## Natural Resources Access Regulator

Our ref: IDAS1134340  
Your Ref: DA2021/0179  
CNR-19464 A-22783

**Re: Request for additional information for proposed development 255 CONDAMINE STREET MANLY VALE 2093**

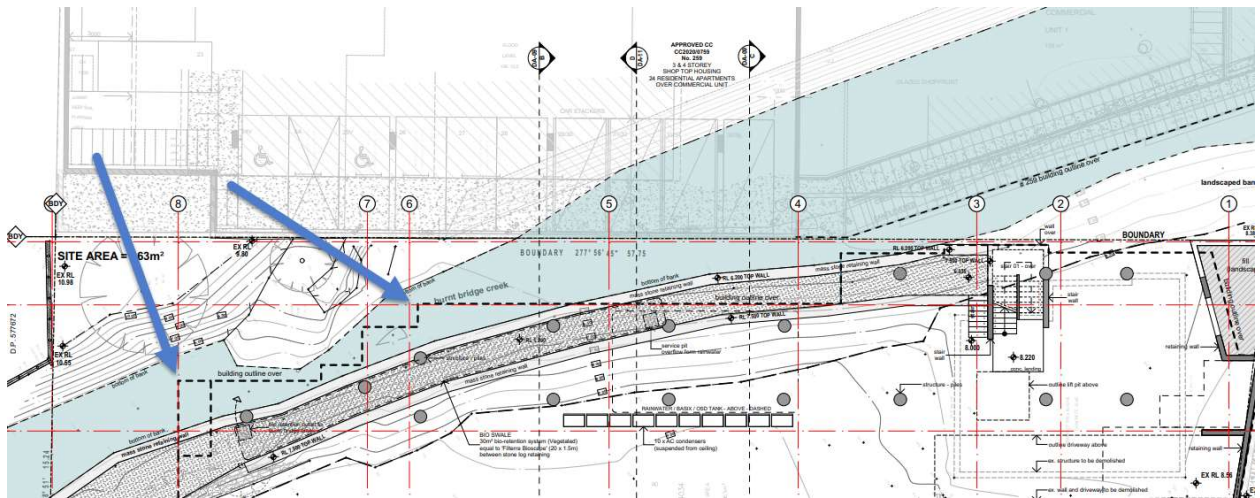
The proposal shows the building overhanging the low flow of the watercourse. The north west corner area is over nearly all of the water flow.

Please show plans in keeping with the above advice.

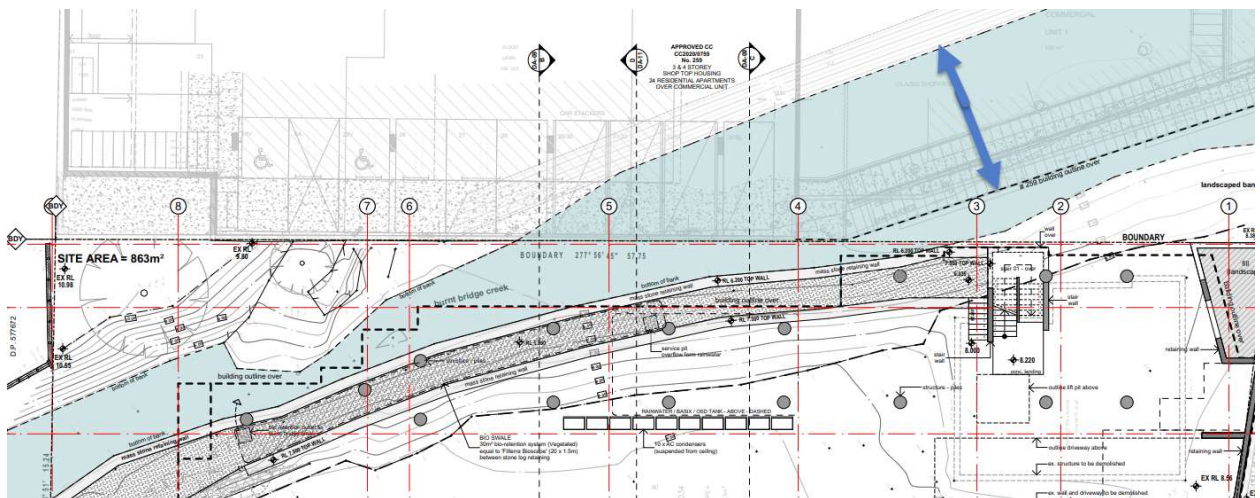
The proponent has made the low flow channel of the watercourse much larger than it actually is to make their proposal seem like less of an impact. The area below is all bank and doesn't go over the water as their proposal plans to.

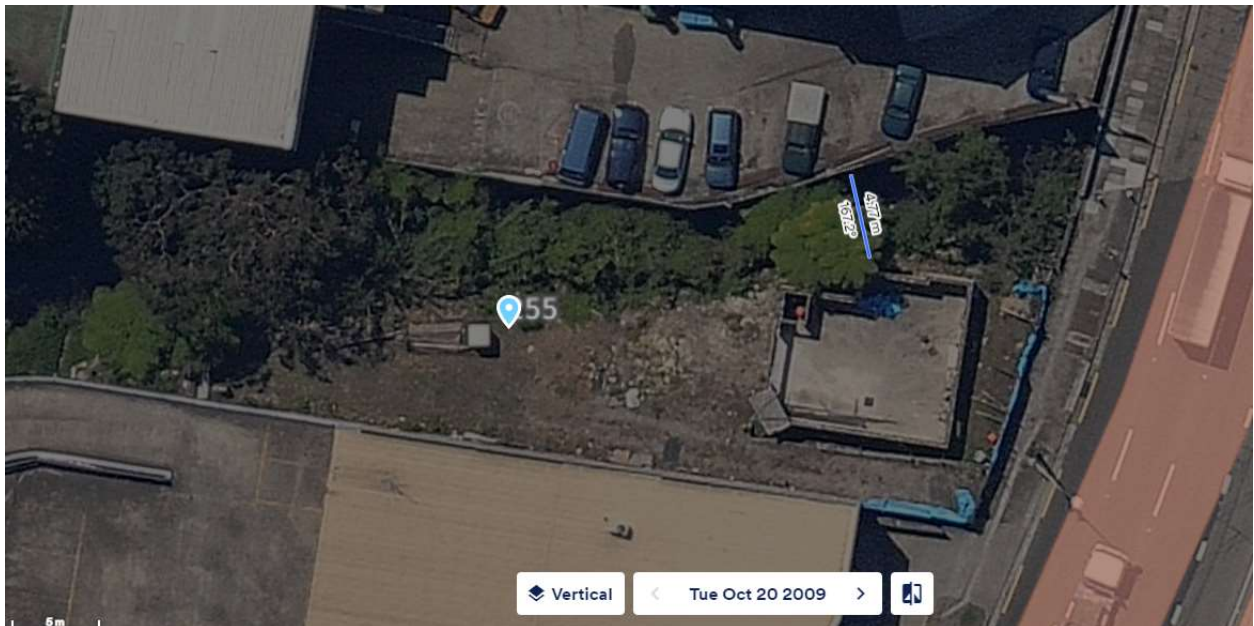
The adjacent building has replaced itself as it previously was and taken no more room than it did before except in height. See below – previous and current.

The bank works on the adjacent building, or this site, would normally not be supported by NRAR but the previous building was already there and could have remained, and the watercourse is then piped under the road and shopping centre.

I have spoken to the proponent about this site in the past and told them that the building is not to overhang any water, meaning the low flow. The adjacent building is not a justification for their building, as they have tried to show, and they need to show their building is not overhanging the watercourse as submitted to us.
